**RESPONSE TO SUBMISSIONS REPORT  
SHOALHAVEN HOSPITAL REDEVELOPMENT  
SSD DA 35999468**

**PART A – MAIN REPORT**

**Prepared on behalf of Health Infrastructure**

### **SSD DA 35999468 SHOALHAVEN HOSPITAL REDEVELOPMENT SHOALHAVEN STREET, NOWRA**

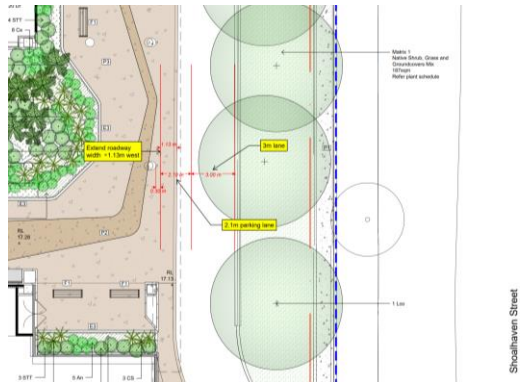
<b>Earthworks</b>	
The concept bulk earthworks plans show a cut volume of 17,734m <sup>3</sup> and fill volume of 3,403m <sup>3</sup> . This results in a significant excess of 14,331m <sup>3</sup> , which is not seen as a design that responds to the natural landform and topography.	<p>Conrad Gargett has considered this comment and advised that the design concept was to minimise the bulk of the new acute services building on the site so that visual impact from the adjacent parkland was minimised.</p> <p>The cut volume is predominately at level 0 to provide a larger footprint at the Shoalhaven Street level, hidden from the street. It enables the back of house activities that support the hospital to have direct access from Shoalhaven Street and minimise access roadworks.</p> <p>It also consolidates support activities close to the central lift core and reduces the volume of the building that is seen above the ground.</p> <p>The natural topography of the site is maintained as the building access points respond to existing contour lines. There is minimal cut and fill work within the building surrounds. Roadworks and landscaping generally following the natural ground lines.</p> <p>In addition Bonacci advises as follows with respect to the cut/fill balance.</p> <p>Connections needed to existing buildings and as such the level of the building for those floors was fixed. With a connection needed to Shoalhaven</p>

Street, and required floor to floor heights for hospital, this set lower floor levels. The required clinical floor planning, and connection between upper and lower levels, also drove extent of footprint at lower level, which resulted in the cut/fill volume evolution. Slope across the site is in the order of 7m, which leads to the cut volumes.
Quite a lot of the cut proposed is within an existing rock layer which would require extensive mechanical means of removal such as rock breaking / hammering / sawing. This is likely to cause great impact on adjacent residents who would need to deal with the noise and vibration impacts associated with these works. Ideally, the amount of cut within rock should be minimised.	<p>Bonacci indicates the volume of rock excavation is approximately 2,000m<sup>3</sup>, so rock cut is not a large proportion of the overall cut.</p> <p>Also, as noted in the EIS a construction noise management plan will still need to be developed prior to construction commencing that includes:</p> <ul style="list-style-type: none"> <li>• Identification of sensitive receivers potentially impacted and nominates noise and vibration management objectives for each.</li> <li>• Identification of the proposed significant construction activities, plant and processes and times of site operation.</li> <li>• Predictions and assessments of noise and vibration impacts and recommended appropriate controls.</li> <li>• Nominated complaint handling procedures and responses, community liaison principles and site management practices to be adopted.</li> </ul>
